Subject: Indian Point 3 Nuclear Power Plant
Docket No. 50-286
Additional Information Related to NUREG-0737, Item II.D.1;
Pressurizer Safety and Relief Valves (PRZR. S/RVs) Testing

RESPONSE TO NRC 6/6/85 REQUEST
FOR ADDITIONAL INFORMATION
REGARDING
NUREG-0737, ITEM II.D.1
PERFORMANCE TESTING OF PRESSURIZER
SAFETY AND RELIEF VALVES

NEW YORK POWER AUTHORITY
INDIAN POINT 3 NUCLEAR POWER PLANT
DOCKET NO. 50-286

FIG. 7 PRESSURIZER S/RV DISCHARGE SYSTEM SCHEMATIC

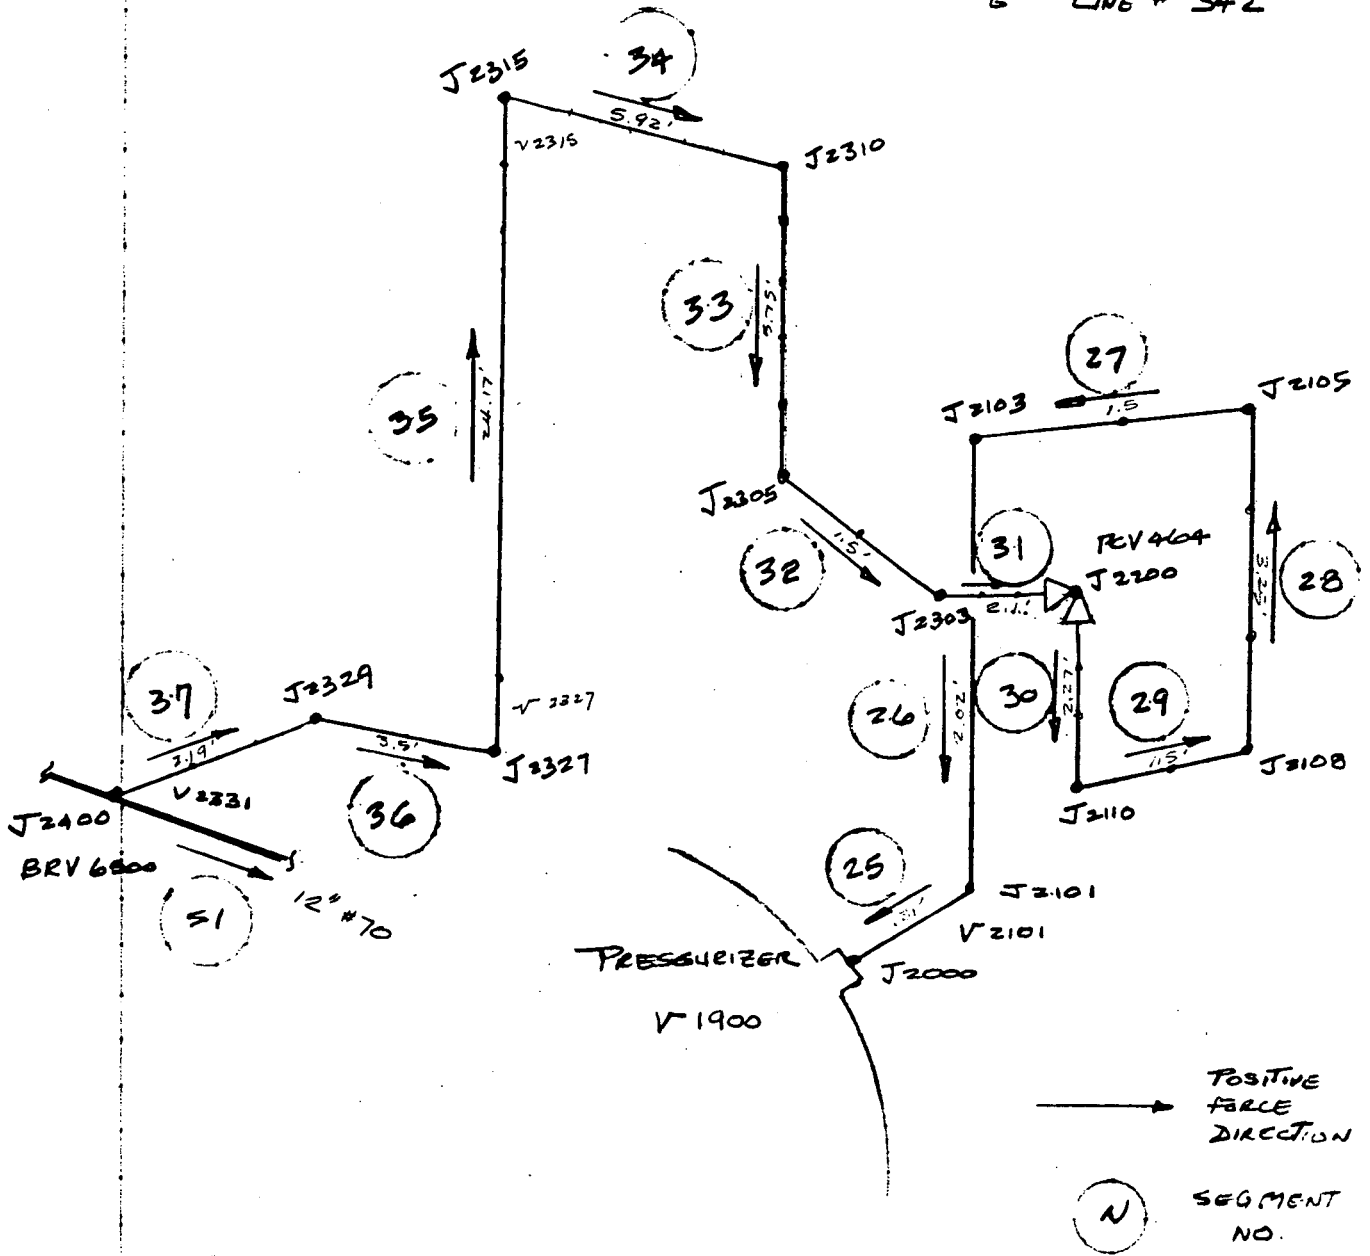
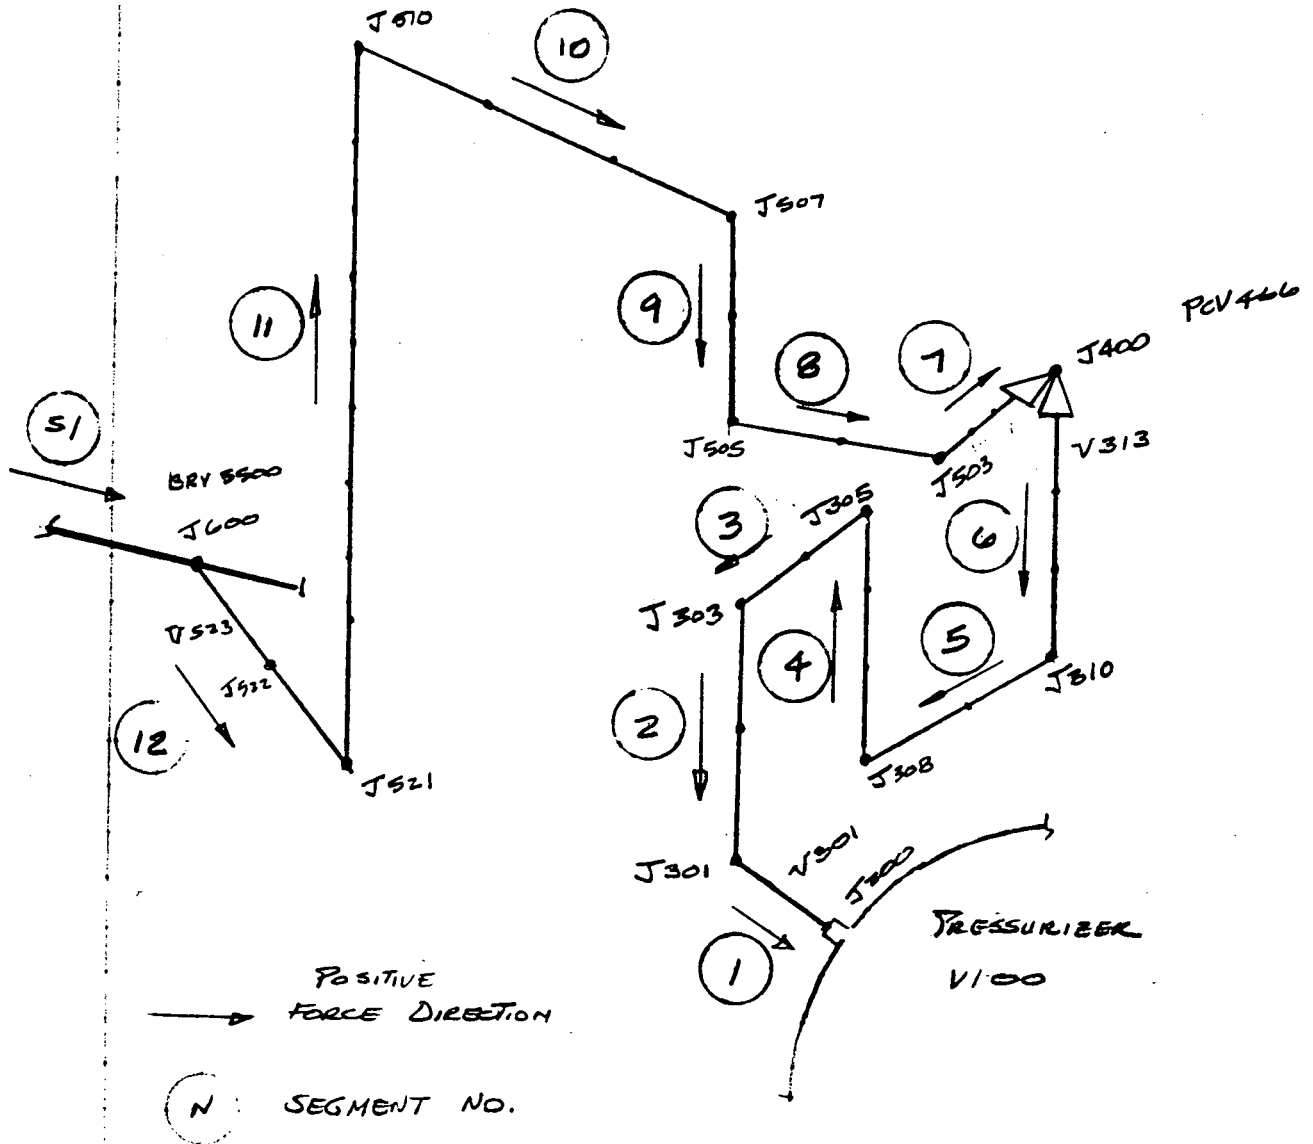
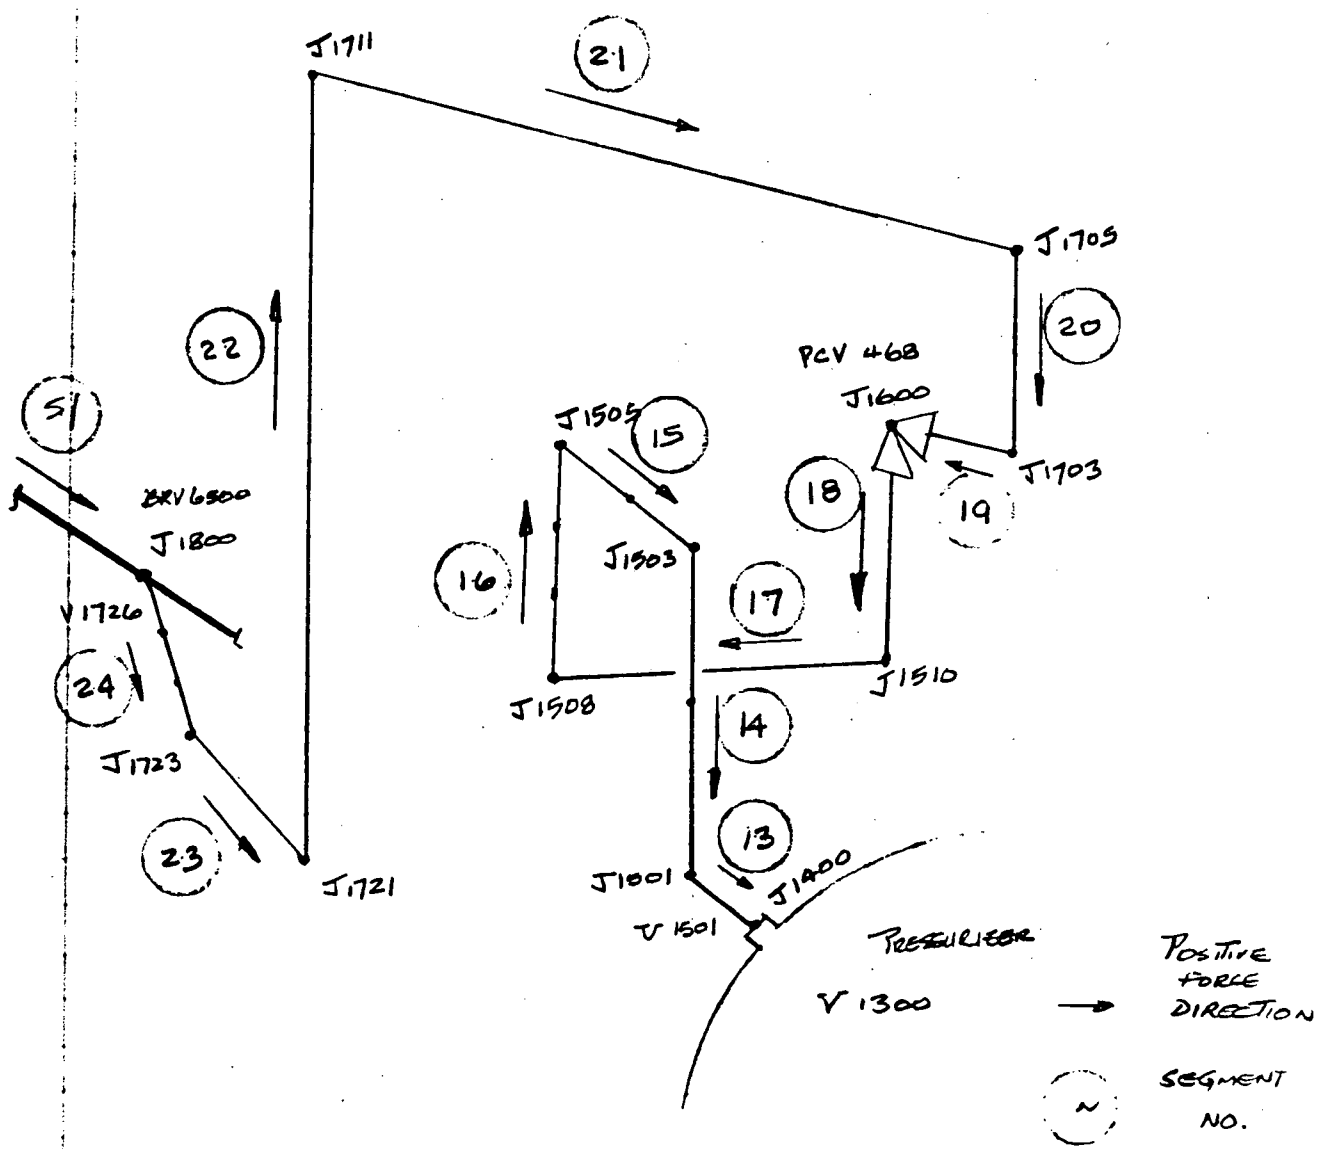
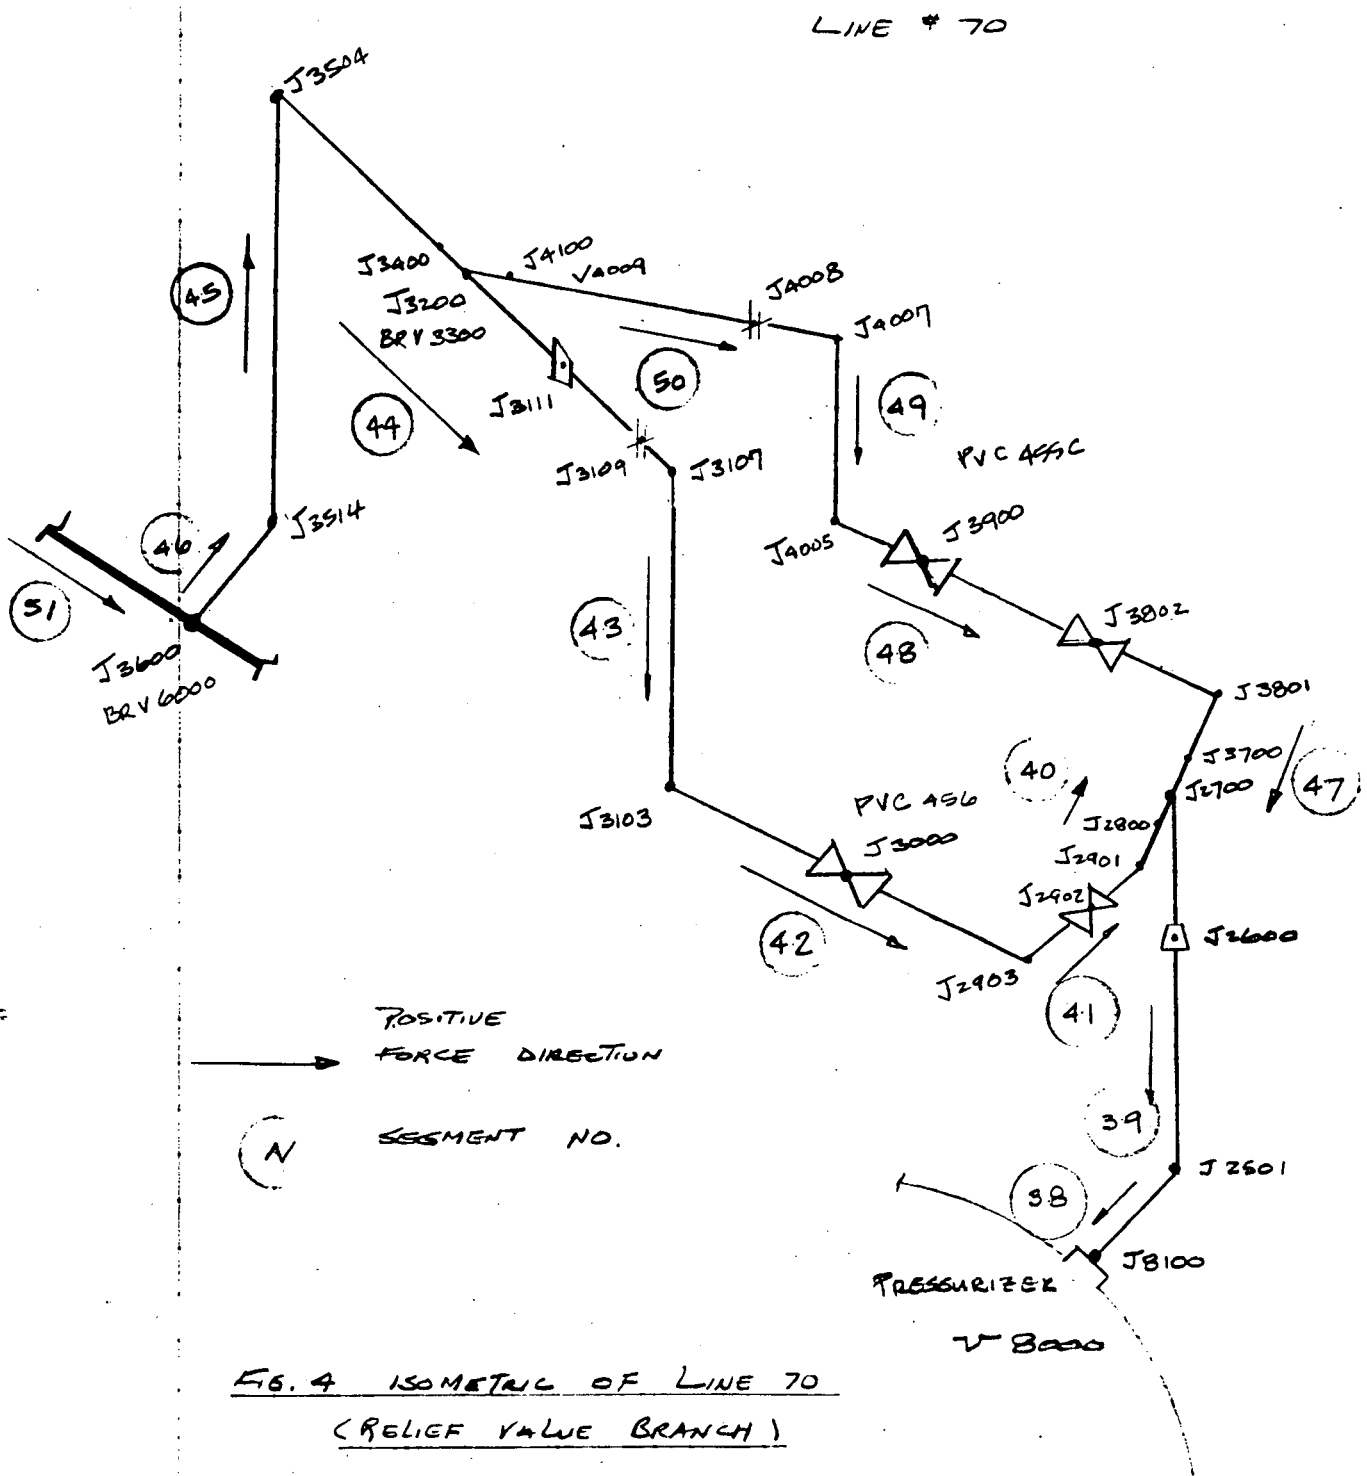
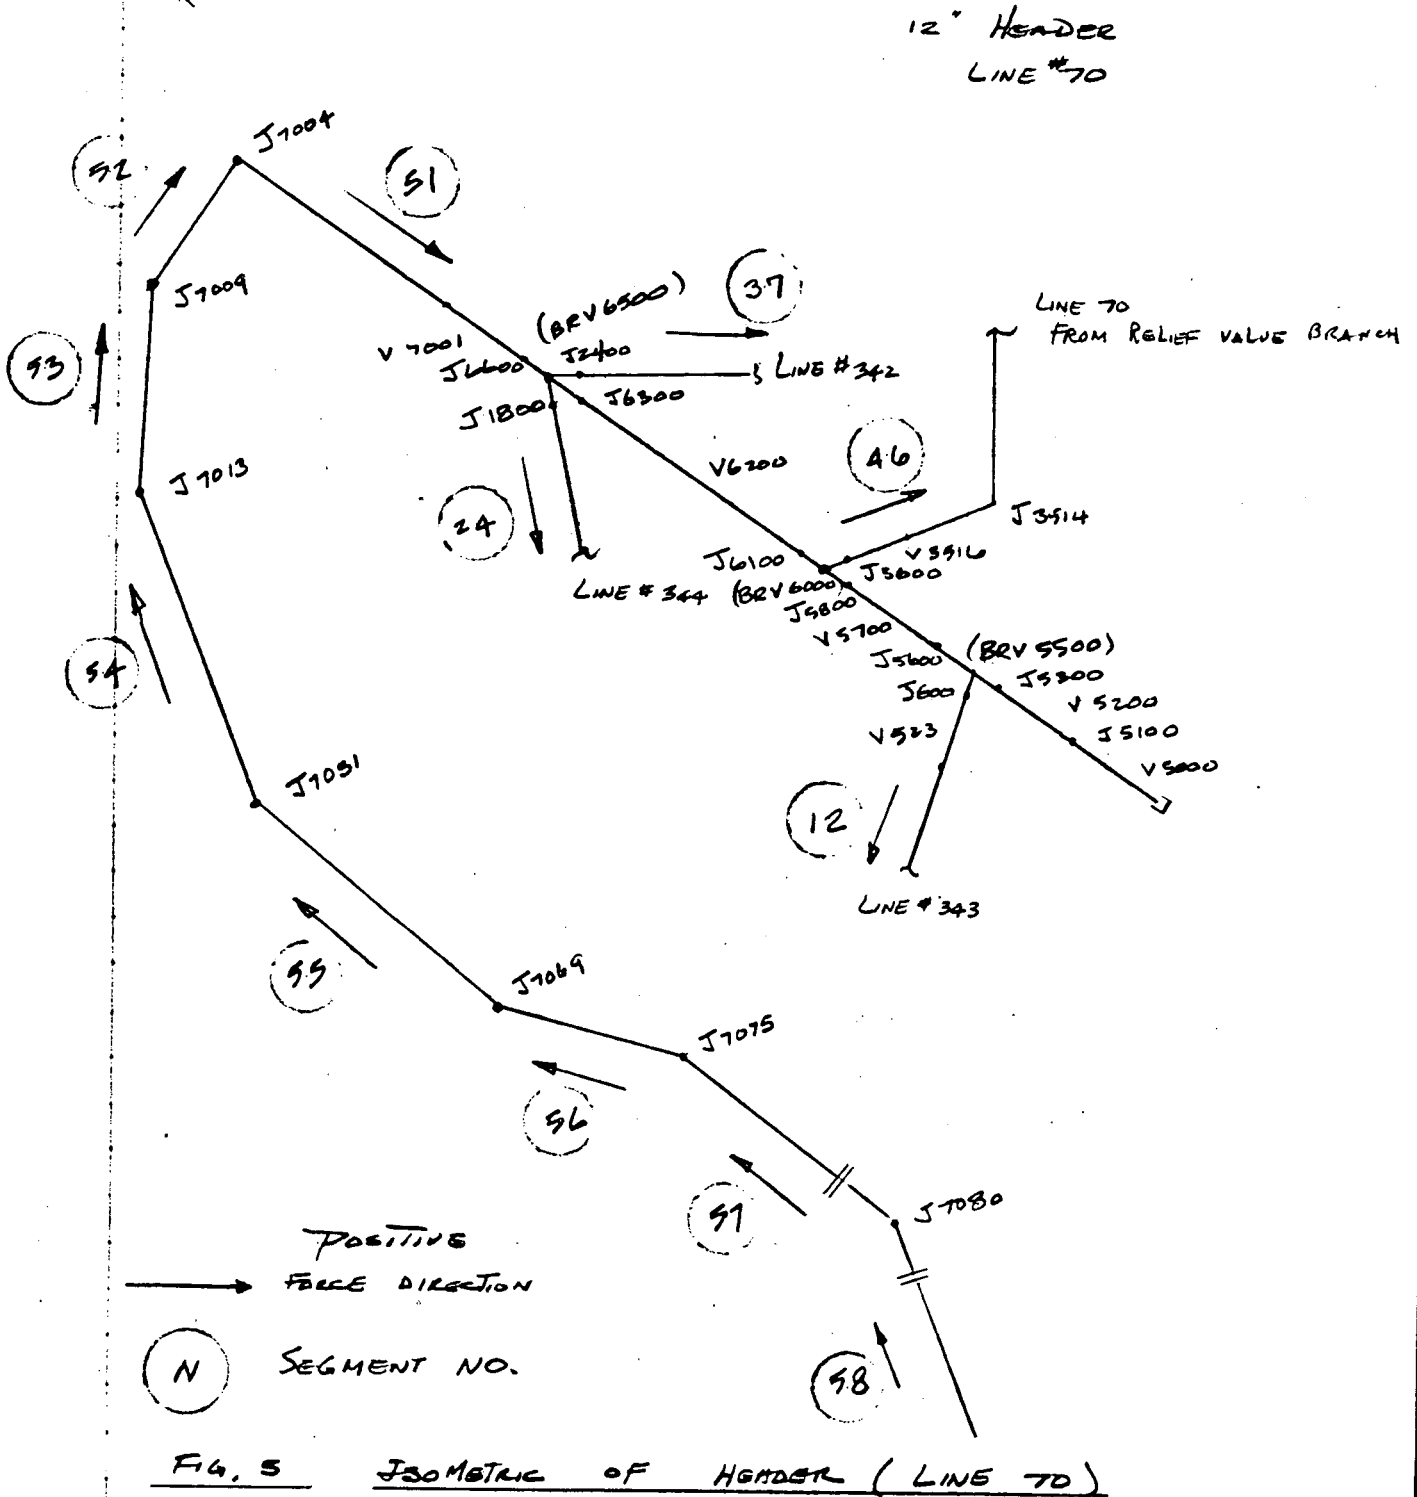
- (e) A discussion of the sequence of opening of the safety valves that was used to produce worst case loading conditions.
- (f) A sketch of the thermal hydraulic model showing the size and number of fluid control volumes.
- (g) A copy of the thermal analysis report.

11 (f) Isometrics of the thermal hydraulic model are shown in Figure 1 through 7 attached. The model consists of 292 volumes and 310 junctions. The average length of volume is less than one foot.
